[Docket No. FAA-2016-4228; Directorate Identifier 2015-NM-107-AD]

Airworthiness Directives; Airbus Airplanes

ACTION: Notice of proposed rulemaking (NPRM).

SUMMARY: We propose to supersede Airworthiness Directive (AD) 2014-13-12, for all Airbus Model A318, A319, A320, and A321 series airplanes. AD 2014-13-12 currently requires identifying the part number and serial number of each passenger oxygen container, replacing the oxygen generator manifold of any affected oxygen container with a serviceable manifold, and performing an operational check of the manual mask release, and doing corrective actions if necessary. Since we issued AD 2014-13-12, we have determined that affected containers have not only been marked with company name B/E Aerospace, as was specified, but also, for a brief period, with the former company name DAe Systems. This proposed AD would retain the requirements of AD 2014-13-12, and require replacing the oxygen generator manifold of any affected DAe oxygen container with a serviceable manifold. We are proposing this AD to detect and correct non-serviceable oxygen generator manifolds, which could reduce or block the oxygen supply and result in injury to passengers

Figure 1 to paragraph (i)(7) of this AD – Design A of the Passenger Oxygen Containers Affected by this AD

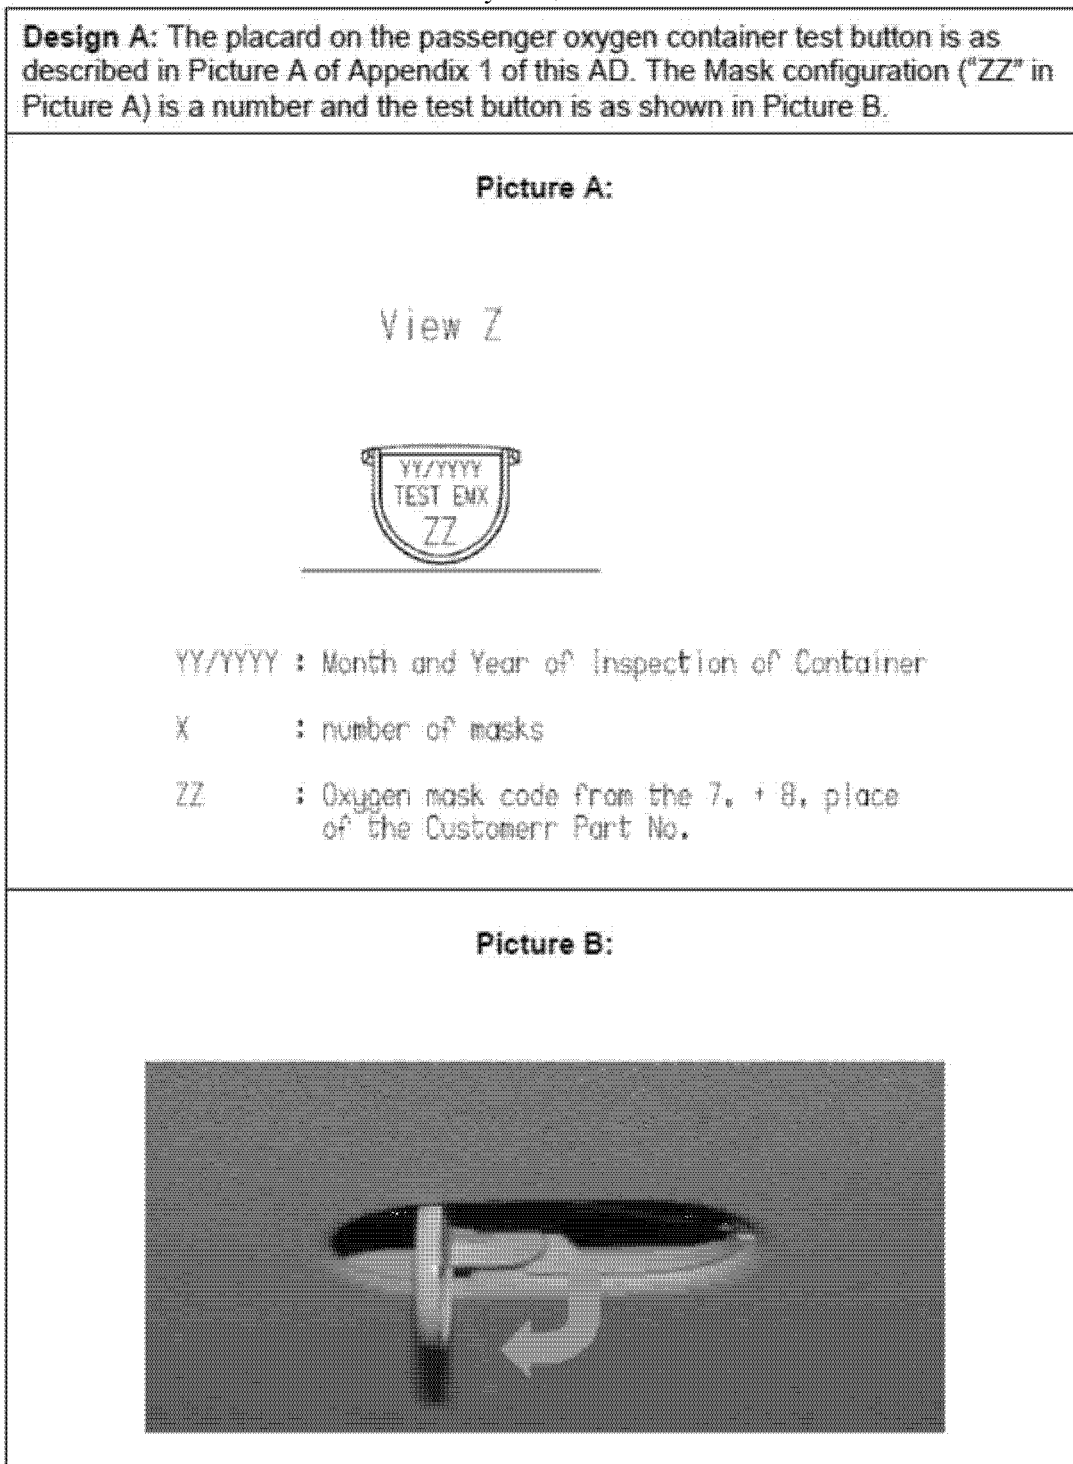
We have added Note 2 to figure 1 to paragraph (i)(7) of this AD, which provides information to clarify information presented in figure 1 to paragraph (i)(7) of this AD.

(7) The requirements of paragraphs (g) and (h) of this AD apply only to passenger oxygen containers that are Design A, as defined in figure 1 to paragraph (i)(7) of this AD.

Note 2 to figure 1 to paragraph (i)(7) of this AD: For “Design A,” the placard on the passenger oxygen container test button is as

described in “Picture A” in figure 1 to paragraph (i)(7) of this AD. The mask configuration (“ZZ” in “Picture A”) is a number, and the test button is as shown in “Picture B.”
